SUPPLEMENTARY RESPONSE TO SUBMISSIONS HORSLEY LOGISTICS PARK

State Significant Development
Application (SSD-10436)

Prepared for
ESR AUSTRALIA
22 December 2020

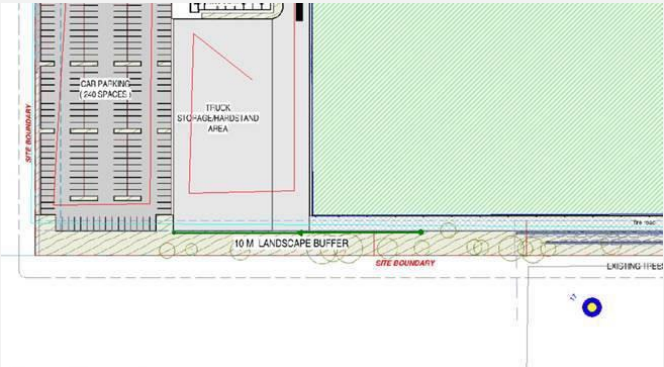
- The effectiveness of the proposed acoustic barrier cannot be meaningfully assessed
 - The inclusion of reversing alarm noise levels will result in a predicted LAeq(15 minute) noise level of 47 dB(A) at the boundary of the Jacfin Residential Land, being a 9 dB(A) exceedance of the established nighttime noise criterion that cannot be mitigated by the proposed barrier.

- A detailed assessment of sleep disturbance has not been conducted by the Applicant.
 - The use of at receiver mitigation is not considered a suitable or reasonable mitigation measure for the future residences on the Jacfin Residential Land.

- In order to assess the possibility of sleep disturbance from peak events, heavy vehicle brake releases and reverse alarms (non-tonal) have been modelled at all points along the heavy vehicle routes and in the hardstand areas of the development with a conservative L_{Amax} SWL of 117 dB, and light vehicles have been modelled with a L_{Amax} SWL of 100 dB.

- The maximum noise levels from the hardstand are predicted to be L_{Amax} 53 dBA, which is 1 dB above the sleep disturbance screening level at the Jacfin land and not 2 dBA as stated in the Jacfin submission. It is important to note that the screening level is not a criterion or noise limit, rather it indicates that further assessment of potential maximum noise impacts is required as stated in Section 2.5 of the NPfl. The NPfl document also states in Section 2.5 that ‘Some guidance on possible impact is contained in the review of research results in the NSW Road Noise Policy (RNP).’

- The Road Noise Policy (RNP) concludes that maximum internal noise levels of 50-55 dBA are unlikely to awaken people. This results in corresponding external noise levels of 60-65 dBA assuming a 10 dB loss through open windows.
